Appeal NO: ABP 314485

Re: A proposed development comprising the taking of a 'relevant action' only within the meaning of Section 34C of the Planning and Development Act 2000, as amended, which relates to the night-time use of the runway system at Dublin Airport.
Dublin Airport, Co. Dublin

RE: Proposed Relevant Action (S.34C of P&D Acts) to amend/replace operating restrictions set out in conditions no. 3(d) & no. 5 of the North Runway Planning Permission (ABP Ref. No.: PL06F.217429) as well as proposing new noise mitigation measures at Dublin Airport, County Dublin

daa plc (the "Applicant"), has retained Tom Phillips + Associates (TPA) to lodge this observation in response to the ABP Draft Decision received under cover of Letter dated 16th September 2024 (the "Draft Decision"). The Draft Decision relates to the 3rd Party Appeal (PL06F.314485) against the notice of decision of Fingal County Council (FCC) to grant permission for the proposed Relevant Action (the "RA") at Dublin Airport. As outlined in our response to ABP to the Third-Party Appeal by St. Margaret's The Ward Residents Group (SMTWRG) and others, dated 17th October 2022, it is the Applicant's position that FCC's Decisi

Figure 1: FCC Noise Zones, FCC CDP 2023-2029 with RSIS Eligibility Contour Areas overlain.

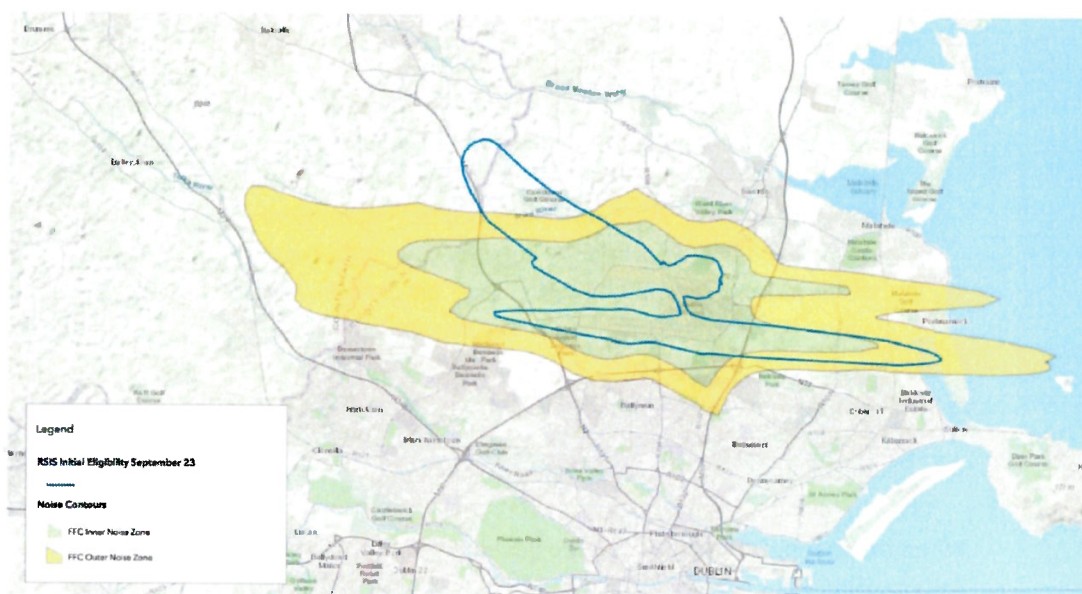
As can be seen in Figure 1 below, the current zone of eligibility³⁵ slightly exceeds the current Noise Zone 'B'³⁶ and historic FCC Outer Noise Zone. Notwithstanding this, new dwellings within this area would fall within the Residential Noise Insulation Grant Scheme and would be subject to mitigation as required by the RD. This would continue to be the case until a future alignment of the existing noise zones with the relevant contours occurs. Furthermore, all new dwellings constructed within the noise zones would be subject to insulation already by way of the current insulation scheme or by way of developer provided insulation as imposed by FCC.

For the avoidance of doubt, it should be noted that the Lnight contour is an external noise metric. It relates to external noise levels. Therefore should the NAO be interpreted to mean that all future consented developments (that are subject to insulation) within the 55dB Lnight contour are included in the calculation of those exposed to aircraft noise above 55 dB Lnight, with no allowance being made for the noise insulation applied, it would effectively mean that full compliance with the Lnight metric of the NAO could only be achieved by FCC not approving any more development within the Noise Zones. Therefore, limiting population growth within this area to the population of 2019. This would be a direct conflict with existing policy, and an issue that only FCC could control. In this case, a movement cap would be unlikely to achieve compliance, as population within the 55dB Lnight contour will continue to grow in line with FCC Development Plan zoning. As such, new population would be exposed to noise above 55dB, unless all night movements ceased. As such, the Applicant is firmly of the view that insulation must be taken account of as included for in Condition No.3 of ANCA's regulatory decision. The control of development within the vicinity of the airport through land use planning measures and noise zoning, which is outside the control of daa, is also vital to ensuring an acceptable outcome and is recognised by ANCA as part of the suite of controls³⁷. It is clear that land use planning in the vicinity of the airport has evolved to allow the airport sustainably grow in line with national policy whilst protecting those within the area from the effects of noise through insulation. If this land use management approach was not deemed acceptable, the land surrounding the airport should not have been zoned for residential development.
